FirstEnergy Nuclear Operating Company

Subject: Davis-Besse Nuclear Power Station  
Supplemental Information for Technical Specification Change regarding Technical Specification 3/4.7.1.7, "Motor Driven Feedwater Pump System" to Correct the Safety-Grade Designation of the Motor Driven Feedwater Pump Flow Indication in Surveillance Requirement 4.7.1.7.e.2 (LAR 03-0001, TAC No. MB9017).

Davis-Besse Nuclear Power Station (DBNPS)  
License Amendment Request 03-0001  
Motor Driven Feedwater Pump System Flow Indicator  
- Responses to NRC Questions -

DBNPS Updated Safety Analysis Report  
Annotated Figure 10.4-12A  
Auxiliary Feedwater System

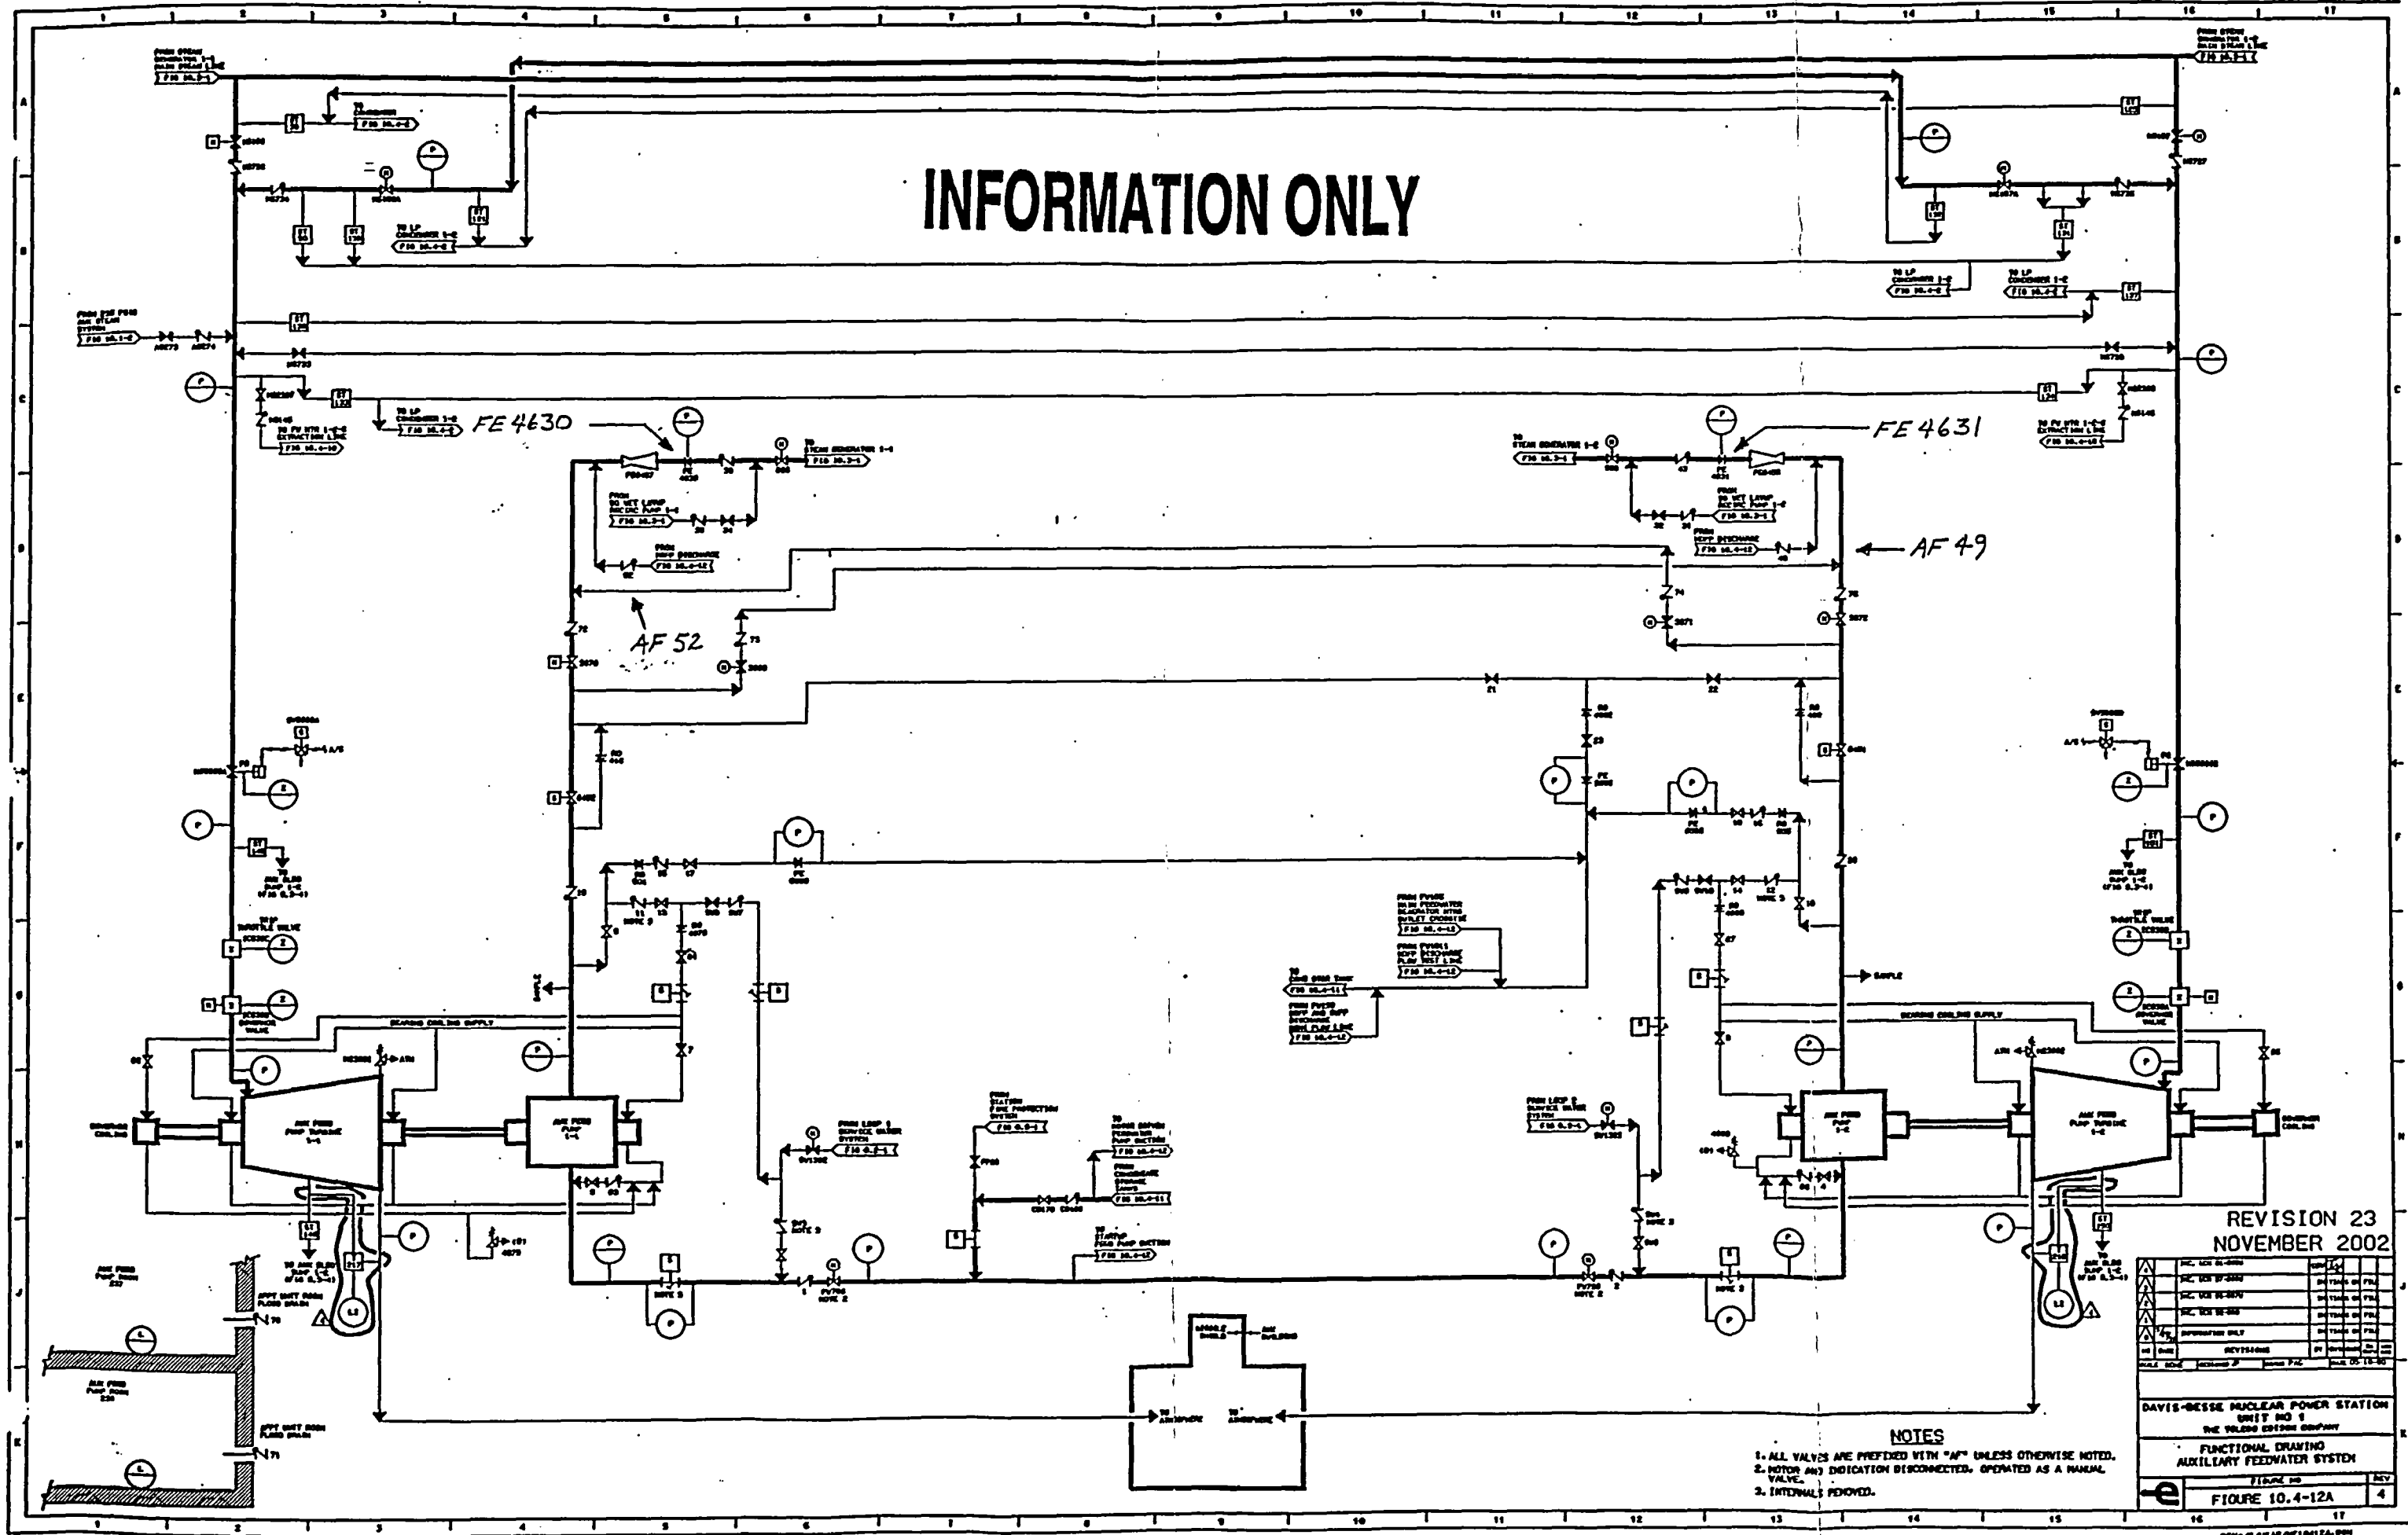
4. NRC Question:

Demonstrate that there is no safety reason for the original requirement that the flow indication be SG [Safety Grade]. Include a discussion of all SG/nonSG interfaces for the AFW [Auxiliary Feedwater] System.

The only AFW System interfaces potentially affected by the proposed change are those with the MDFP System. As shown on USAR Figure 10.4-12A (annotated copy enclosed), the MDFP System interfaces with the safety-grade AFW System at check valves AF49 and AF52, which prevent backflow from the AFW System to the MDFP System. The MDFP System and the AFW System also share a non-safety grade test flow line to the condensate storage tanks.

The MDFP discharge pipe connection to the safety-grade AFW system is upstream of the safety-grade flow indication associated with the AFW piping to each steam generator as shown on USAR Figure 10.4-12A. Accordingly, if the MDFP is in operation and providing feedwater to the steam generators, the flow will be indicated by safety-grade indication FE/FI 4630 for steam generator 1-1 and safety-grade indication FE/FI 4631 for steam generator 1-2. These two safety-grade flow indicators are tested under TS SR 4.3.3.6. The AFW System Flow path is demonstrated operable by using these flow indicators under TS SR 4.7.1.2.1.c, 4.7.1.2.1.f, and 4.7.1.2.1.g.

MDFP SR 4.7.1.7.e.2 is a situational-type SR, and is required to be performed only as a post-modification or repair test when the modification or repair is upstream of the MDFP test flow line tie-in to the non-safety related condensate storage tanks. It is not used to determine safety grade flow to the steam generators. Accordingly, there is no safety reason that the MDFP FE/FI 5876 flow indication be safety grade.
